# Product change notification

PCN14-04 – KMR

As part of this continuous improvement policy, C&K Components has engaged a program around the KMR series. This program consists of improvements related to the inside protection film.

Actual configuration

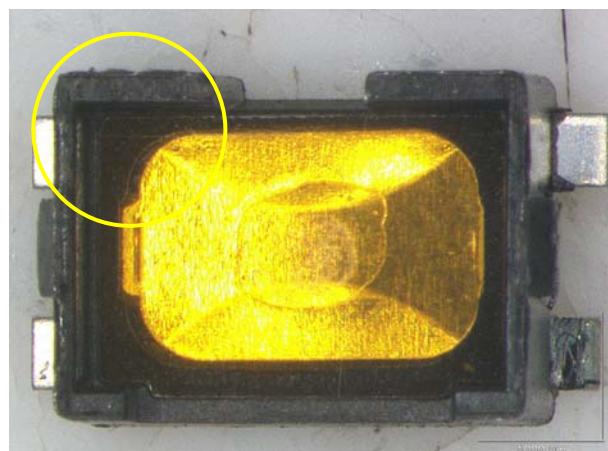
- ⇒ Replacement of Teflon foil by a Kapton Foil.
- ⇒ Optimization of adhesive surface.

Ground pin version

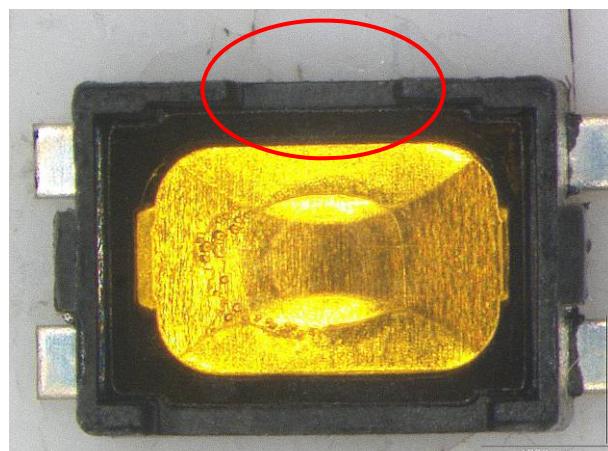
- ⇒ Until now, both G and NG versions (with or w/o ground pin) were sharing a common over molding. In the new configuration, the NG version (w/o ground pin) over molding is different as can be seen on the pictures below. This does not affect all the other dimensions and characteristics.
